HISTORIC AND DESIGN REVIEW COMMISSION

HDRC CASE NO: 2020-294
ADDRESS: 129 E SUMMIT AVE
LEGAL DESCRIPTION: NCB 3258 BLK 2 LOT 14 & W 50 FT OF 13
ZONING: R-5, H
CITY COUNCIL DIST.: 1
DISTRICT: Monte Vista Historic District
APPLICANT: kelly hoopes
OWNER: Bob Binovi/BINOVI ROBERT D & JEANNE P
TYPE OF WORK: Window replacement
APPLICATION RECEIVED: June 29, 2020
60-DAY REVIEW: Not applicable due to City Council Emergency Orders
CASE MANAGER: Rachel Rettaliata
REQUEST:

The applicant is requesting a Certificate of Appropriateness for approval to replace one wood window.

Left
Side

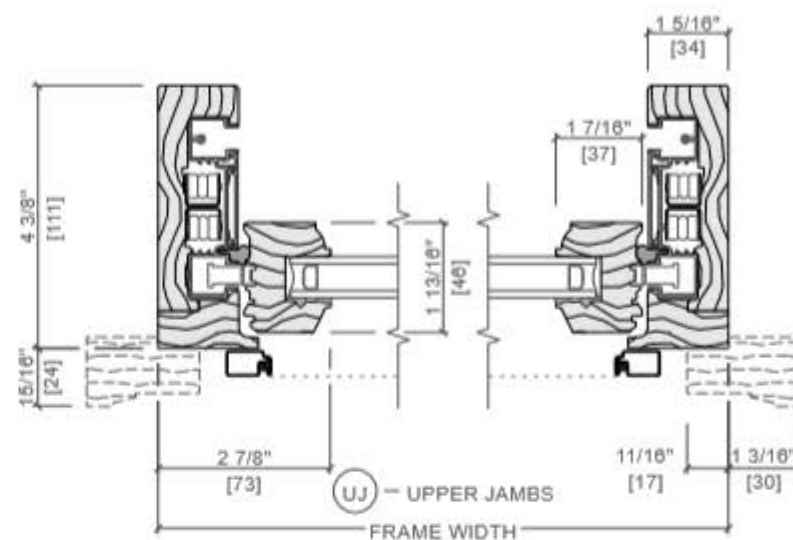
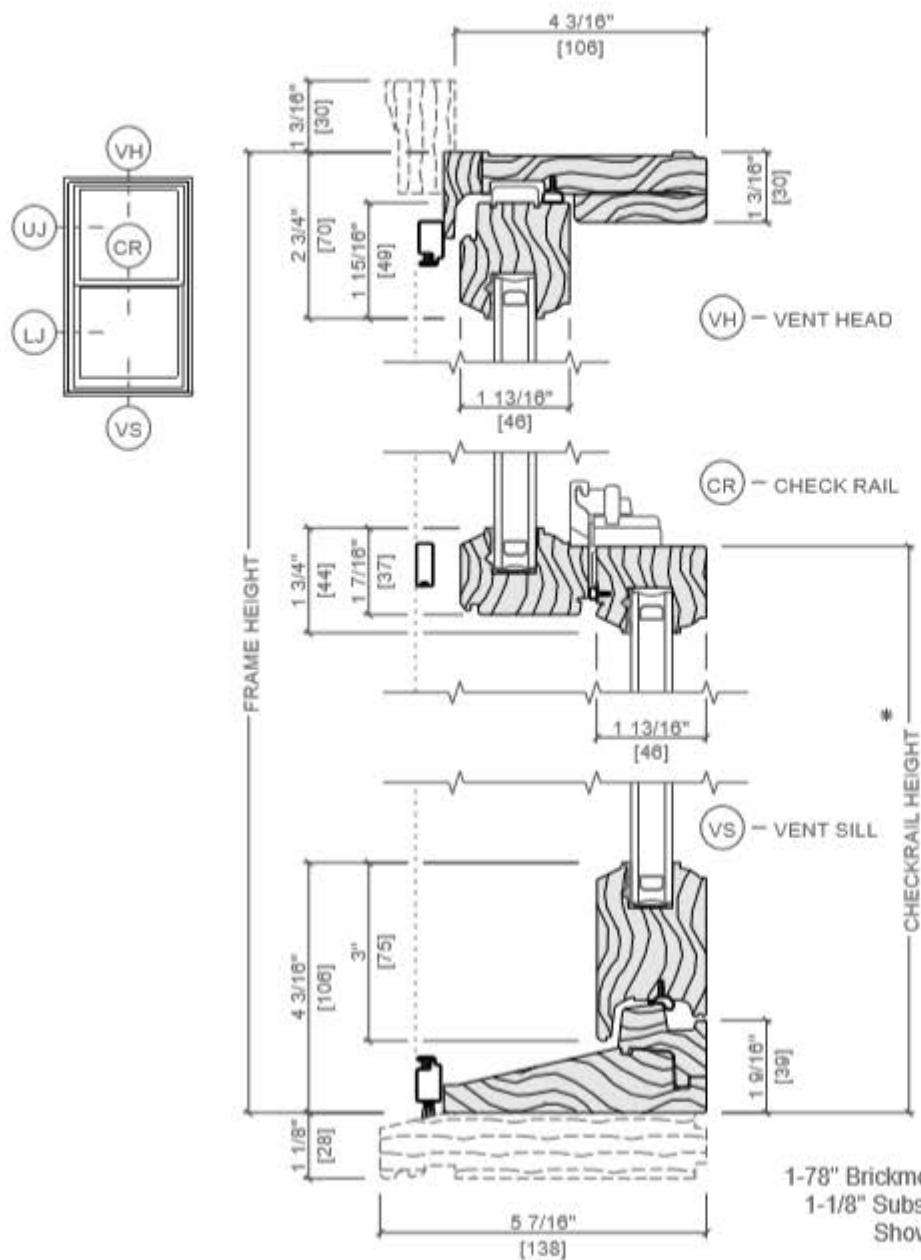
- b. **WINDOW REPLACEMENT: EXISTING CONDITION** – The applicant has proposed to replace one one-over-one wood window located on the west elevation. The window may be original to the structure but does not match the other eight-over-eight windows on the house. The applicant has proposed to replace the existing window with a fully wood Pella Reserve Traditional Hung Window. Guideline 6.A.iii for Exterior Maintenance and Alterations states that historic window should be preserved. Additionally, Guideline 6.B.iv for Exterior Maintenance and Alterations states that new windows should be installed to match the historic or existing windows in terms of size, type, configuration, material, form, appearance, and detail when original windows are deteriorated beyond repair. The documentation provided does not provide evidence that the window is deteriorated beyond repair. Staff finds the proposal inconsistent with the Guidelines and finds that the existing window should be repaired in place.

Staff does not recommend approval based on findings a through c. Staff recommends that the applicant repair the existing window in place.

Pella® Reserve™ Traditional Hung Window

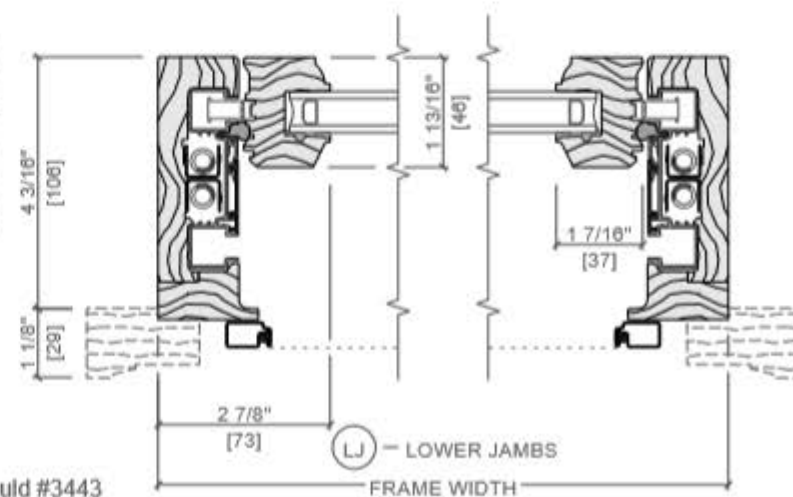
- c. **WINDOW REPLACEMENT: REPLACEMENT PRODUCT** – The applicant has proposed to replace an existing one-over-one wood window with a fully wood Pella Reserve Traditional Hung Window. According to the Standard Specifications for Original Wood Window Replacement, meeting rails must be no taller than 1.25". Stiles must be no wider than 2.25". Top and bottom sashes must be equal in size unless otherwise approved. The proposed replacement product matches the existing product in material, configuration, and form. However, the proposed replacement product features meeting rails that are 1.75" tall and stiles that are 1.43" wide. The meeting rails proposed are taller than the specified 1.25". Staff finds the proposal inconsistent with the Standard Specifications for Original Wood Window Replacement.

- i. That the applicant replaces the existing window with a fully wood window product that meets staff's standard window specifications and submits updated specifications to staff for review and approval. The windows should feature an inset of two (2) inches within facades and should feature profiles that are found historically within the immediate vicinity. Meeting rails must be no taller than 1.25" and stiles no wider than 2.25". White manufacturer's color is not allowed, and color selection must be presented to staff. There should be a minimum of two inches in depth between the front face of the window trim and the front face of the top window sash. This must be accomplished by recessing the window sufficiently within the opening or with the installation of additional window trim to add thickness. Window trim must feature traditional dimensions and architecturally appropriate sill detail. Window track components must be painted to match the window trim or concealed by a wood window screen set within the opening.
